STE Hackney

SERVICE BULLETIN:

230214

Red Bull Bumpers

ISSUE:

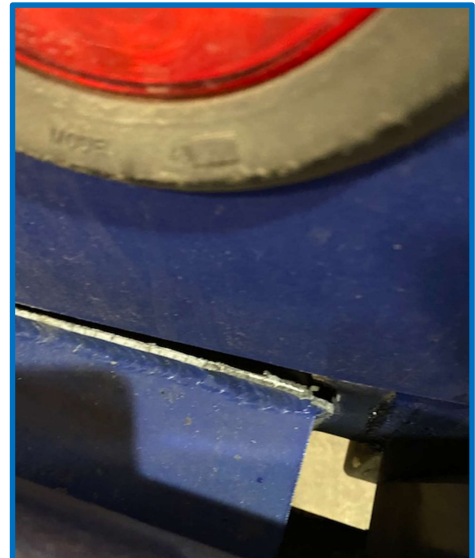
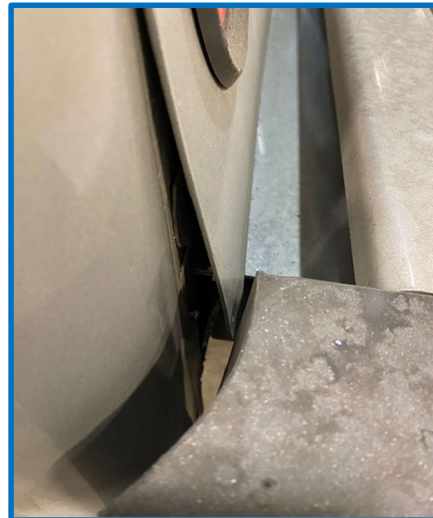
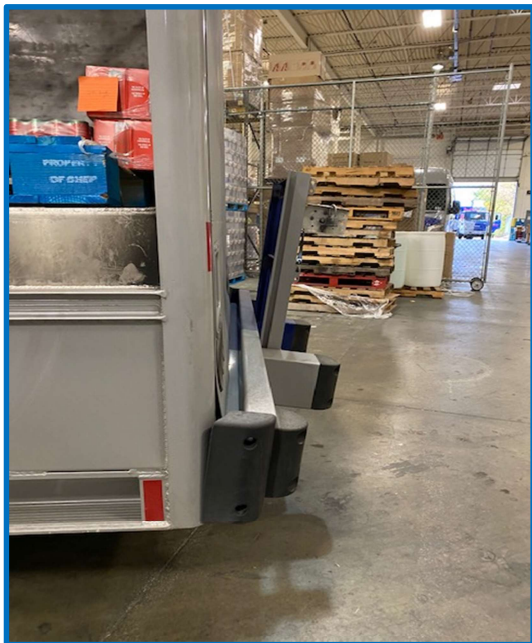
Some 2016 - 2018 Red Bull units have experienced cracking around the welds that secure the rear bumper to the rear frame. The cracking is caused by the forces applied by the rear bumper with loaded hand cart rack under repeated use. Engineering changes were made in 2018 (West) and 2019 (East) units to stiffen the internal rear frame and bumper structure.

1. Inspection

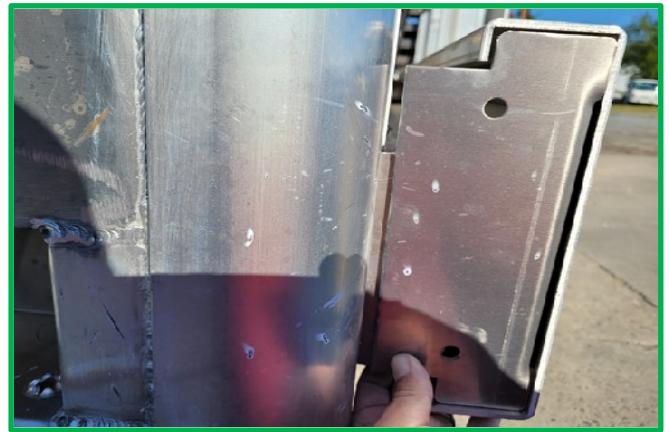
Inspect the bumper for cracking at welded attachment to the rear frame.

IF cracks evident = contact Hackney warranty. We will review and arrange for repairs.

IF NO CRACKS evident -- contact Hackney warranty and we will arrange for the addition of a support plate to both outside bumper ends to prevent future cracking.
